Audio Codec '97
Errata Sheet

REVISION HISTORY

9.2.3. Data Setup And Hold

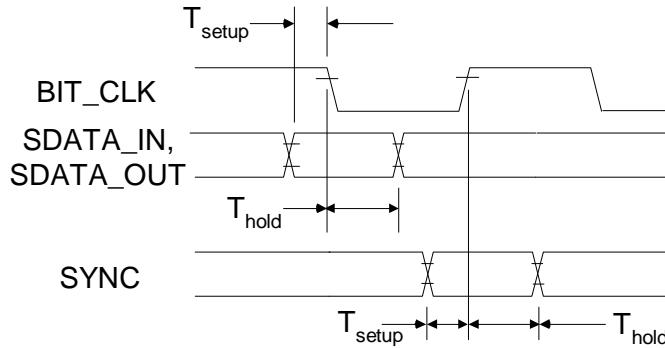
Page 43, 9.1., parenthesis: ($T_{ambient}$ = 25^{0}C, AVdd = DVdd = 5.0 V or 3.3V **+/- 5%;** ...
	Page 43, 9.1., NOTE: ... either 5.0V or 3.3V **(+/- 5%),** ...
	Page 43, 9.1., para 2: added 2nd paragraph and 2 tables specifying PCI 2.1 compliant 5.0 V and 3.3 V operation
	Page 46, 9.2.3., figure: shows setup and hold times for SYNC, SDATA_OUT, and SDATA_IN (at Controller)
	Page 46, 9.2.4., table: added 6nS spec for Max rise and fall times (for all entries in table)
	Page 48, 10., parenthesis: ... $T_{ambient}$ = 25^{0}C, AVdd = DVdd = 5.0 V **+/- 5%;** ... tone and 3D disabled).
	Page 48, 10., Table: Vrefout spec'd at 2.25 - 2.75 V typical
	Page 48, 10., Note 7: added clarification of Stop Band rejection
	Page 48, 10., Note 8: added clarification of Out-of-Band rejection

Parameter	Symbol	Min	Typ	Max	Units
Setup to falling edge of BIT_CLK	T_{setup}	15.0	-	-	nS
Hold from falling edge of BIT_CLK	T_{hold}	5.0	-	-	nS

Note 1: Setup and hold time parameters for SDATA_IN are with respect to the AC '97 Controller.
